Access Compliance Report

Public Rights-of-Way

Intersection ID: 11597	Main Street: E_20TH_ST	Cross Street: SEIGLE_AV	Location: S
ADA ID: BD0744DC5FFB	Ramp Type: BlendTrans1	Initial Pass/Fail: Fail	Overall Compliance: No
		Severity Score: 12.5

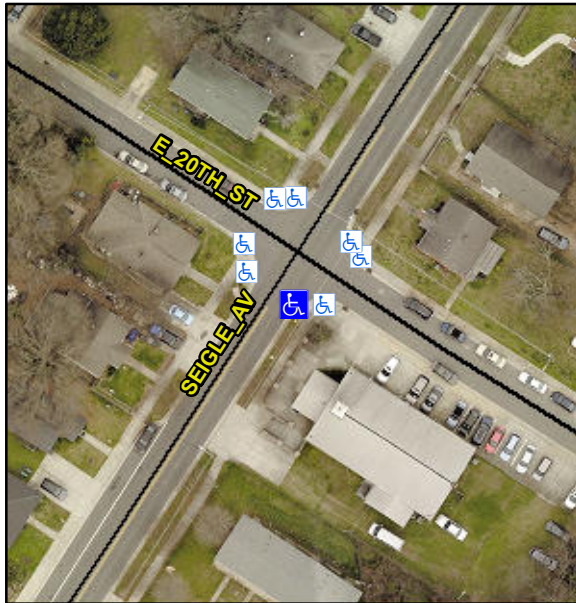
Not Found, R304.5.3

Compliance	Description	Data	Compliance	Description	Data
N/A	Ramp Length (in)	37.0	Yes	BlendTrans Slope (%)	1.1
Yes	Ramp Width (in)	48.0	No	BlendTrans XSlope (%)	6.9
N/A	Flare Type LT	N/A	N/A	Flare Type RT	N/A
N/A	Flare Slope LT (%)	N/A	N/A	Flare Slope RT (%)	N/A
N/A	Flare Traversable LT?	N/A	N/A	Flare Traversable RT?	N/A
N/A	Landing Length (in)	N/A	N/A	DWS Provided?	N/A
N/A	Landing Width (in)	N/A	N/A	DWS Contrast?	N/A
N/A	Landing Slope (%)	N/A	N/A	DWS Length (in)	N/A
N/A	Landing X Slope (%)	N/A	N/A	DWS Full Width?	N/A
N/A	Landing Curb? (Y/N)	N/A	N/A	DWS Offset (in)	N/A
N/A	Shared Landing?	N/A			
N/A	Gutter Ponding?	N/A	N/A	Gutter Slope (%)	N/A
N/A	Gutter Lip Ht (in)	N/A	N/A	Gutter X Slope (%)	N/A
N/A	Painted X Walk1?	No	N/A	Painted X Walk2?	N/A
	X Walk 1 Direction	To NW		X Walk 2 Direction	N/A
	X Walk 1 Width (in)	N/A		X Walk 2 Width (in)	N/A
	X Walk 1 Slope (%)	1.4		X Walk 2 Slope (%)	N/A
	X Walk 1 X Slope (%)	7.9		X Walk 2 X Slope (%)	N/A

Remove & Replace Curb Ramp With Two New Directional Ramps or Equivalent.
